Access Compliance Report

Public Rights-of-Way

Intersection ID: 10038412	Main Street: SOUTH_POINT_BV	Cross Street: N/A	Location:	E
ADA ID: BEF6930F3A16	Ramp Type: Combination1	Initial Pass/Fail: Fail	Overall Compliance: No	Severity Score: 25

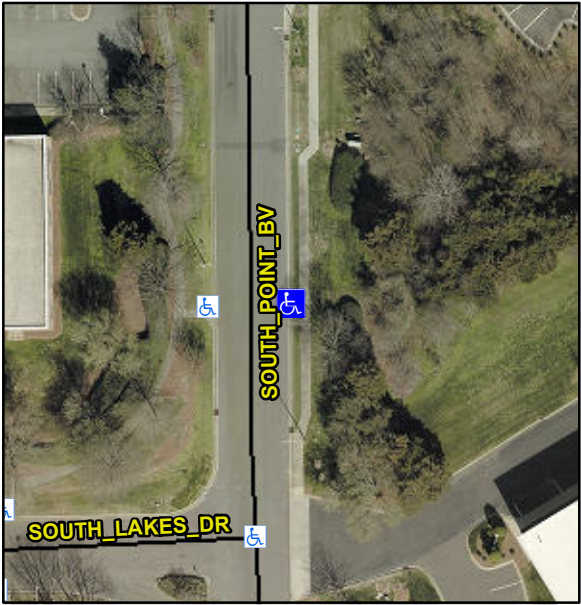
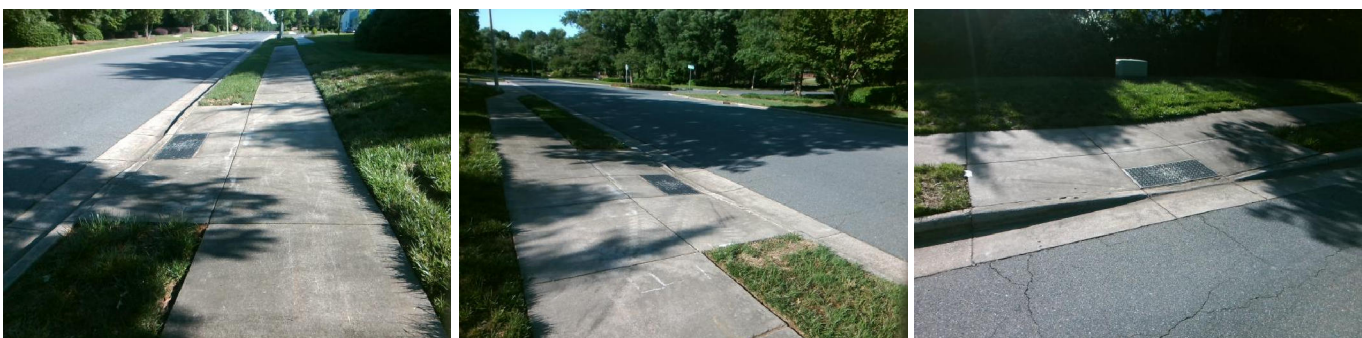
Codes/Mitigation Info/Possible Solution			Field Measurements/Component Compliance			
	Possible Solutions:		Compliance	Description	Data	
	Remove & Replace Entire Ramp.		N/A	Ramp Length LT (in)	72.0	
			Yes	Ramp Width LT (in)	59.0	
			Yes	Ramp Slope LT (%)	7.6	
			No	Ramp XSlope LT (%)	3.1	
			N/A	Ramp Length (in)	49.0	
			Yes	Ramp Width (in)	48.0	
	Surveyor Notes:		N/A	Flare Type LT	N/A	
	RT RP < 5%		N/A	Flare Slope LT (%)	N/A	
			N/A	Flare Traversable LT?	N/A	
			N/A	Landing Length (in)	N/A	
			N/A	Landing Width (in)	N/A	
			N/A	Landing Slope (%)	N/A	
			N/A	Landing X Slope (%)	N/A	
			N/A	Landing Curb? (Y/N)	N/A	
			N/A	Shared Landing?	N/A	
			N/A	Gutter Ponding?	N/A	
			N/A	Gutter Lip Ht (in)	N/A	
			N/A	Painted X Walk1?	No	
				X Walk 1 Direction	To W	
				X Walk 1 Width (in)	N/A	
				X Walk 1 Slope (%)	5.8	
				X Walk 1 X Slope (%)	3.4	
	PROW/ADA:		N/A	Ramp inside XWalk1?	N/A	
	R304.2.2, R304.5.3			Road Slope (%)	N/A

Road X Slope (%)	N/A	
	Total Cost:	\$ 1800.00	N/A	Ramp inside XWalk2?	N/A	
				Clear Space?	N/A	
				Clear Space to XWalk (in)	N/A	
				Any Obstruction?	N/A	
				Obstruction Type		
						N/A
				Storm Grate/Utility Hazard?	N/A	
				Storm Grate/Utility Type		
						N/A
			Yes	Surface Condition? (G/P)	Good	
				Curb Slope (%)	0.7
